ASSESSMENT OPINION

REGARDING POST REGISTRATION CHANGES

KOLAR BIOGAS PROJECT

Report No: 8000429974 – 14/009

Diagram 1: Unit installation, average units operating and survey dates over project Year 1 and 2.

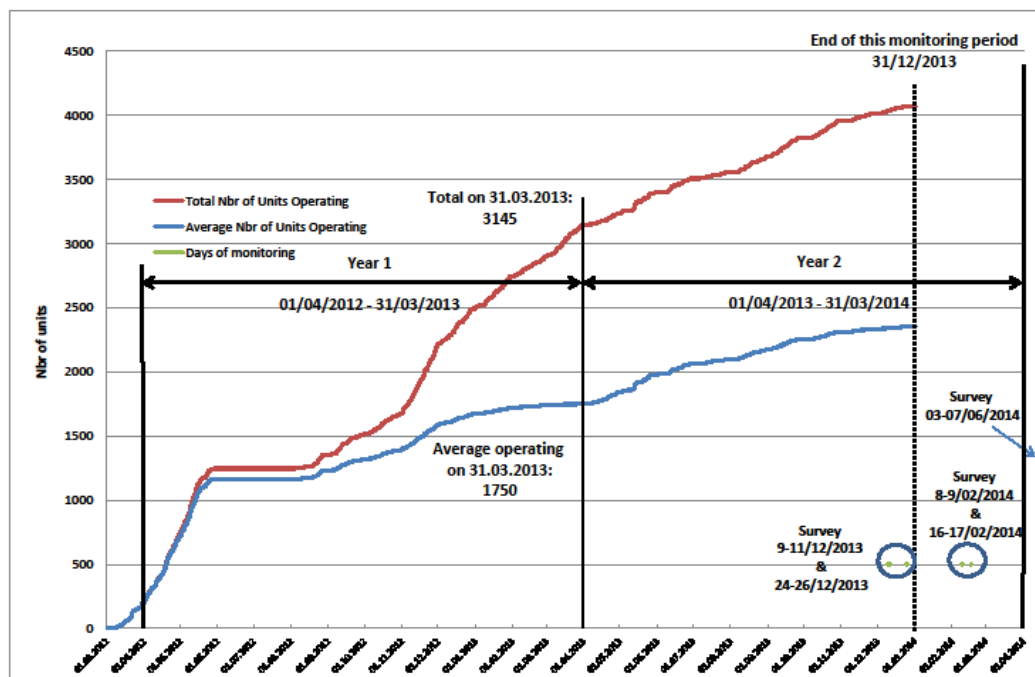
The method of ER calculation is the same. The same equations are used for the calculation of final emission reductions achieved during the first monitoring period. However some values depend on the result of a conducted survey. This survey has been conducted at a later stage as indicated in the registered monitoring period. As per checked data and provided ER spreadsheet the later in time the higher is the number of installed and operating biogas systems.

As per registered PDD and monitoring plan a minimum of 169 project-HHs have to be included in the survey and 58 non-project HHs. During the conducted survey 367 project households and 150 non-project households have been visited and interviewed. This is higher than the required number as required during validation based on the requirements by the standard for sampling and survey. Based on that the required number of HHs have been covered by the conducted survey even considering that the part of the survey is conducted in Year 3 outside this monitoring period. Considering the HHs covered in survey conducted in Year 2 264 project and 150 non-project HHs have been included. From this it can be stated that the required number of HHs in survey in Year 2 has been covered. Checking a higher number of units/households is therefore considered to provide a more accurate result. For the effect on the emission reduction calculation please refer to next point "Conservativeness".

As per PDD the PP proposed to include 100 non-project HHs and 30% of average operating units in Year 1 and from Year 2 onwards 5% of average operating units in the survey. With years the number of average operating units is considered to increase until all units are operating so the number of units covered by the survey. According to the PDD and at that time considered deployment plan in Year 1 30% would have been 250 project-households and 100 non-project HH which should be monitored/part of the survey. DOE has checked the list of households in ER spreadsheet and found that for first monitoring plan at the end of Year 1 on 31/03/2013, 3,145 units have been installed and in average 1,750 units were operating. This would lead to 525 (1,750x0.3) units. At the end of the monitoring period on 31/12/2013 4,069 units have been installed and in average 2,352 units were operating (see also Diagram 1 below). The end of the first monitoring period is in Year 2 for which the PP proposed to include 5% of average units. This would be 118 (2,352x0.05). For Year 2 also the proposed value has been reached.
